**Stephenson Street Flood Defence
Scheme**

Pre-Application Consultation Report

274850-ARP-XX-XX-RP-PL-0006

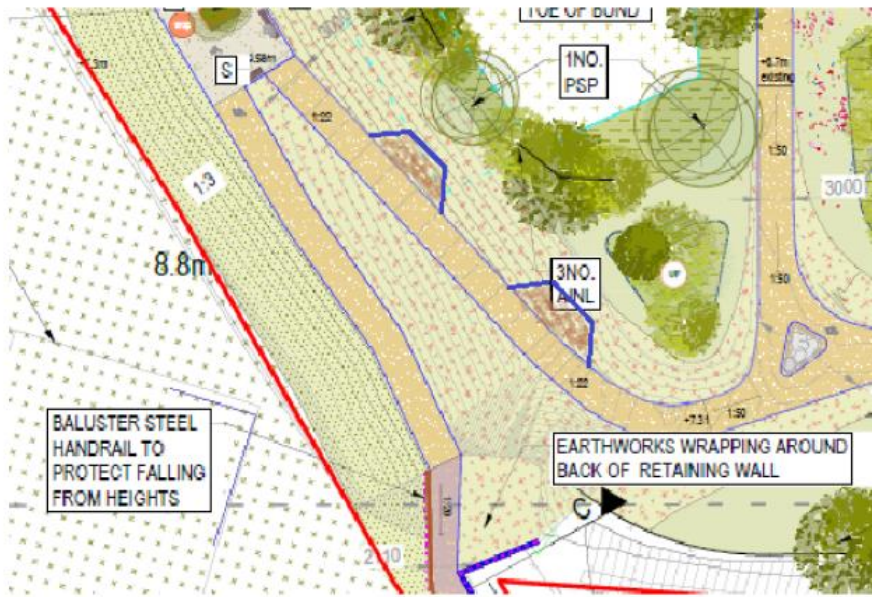
How much of the revamped Wales Coast Path will be wheelchair accessible – all the way to the blue arrow below from the end of the stiped brown surfacing shown below?

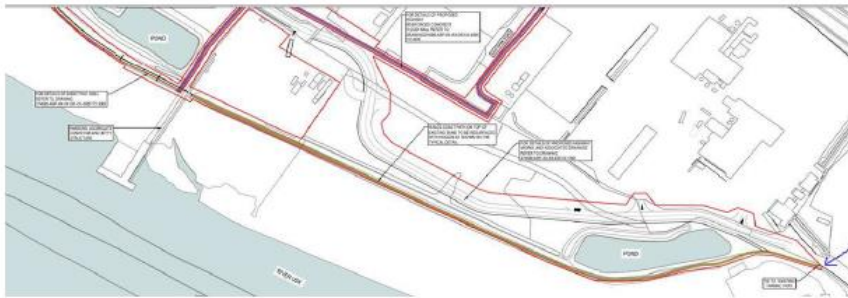
Will there be a turnaround point where it ceases to be wheelchair accessible? Is there a drop of level to where meets tarmac at the blue arrow below? If yes, what is the gradient?
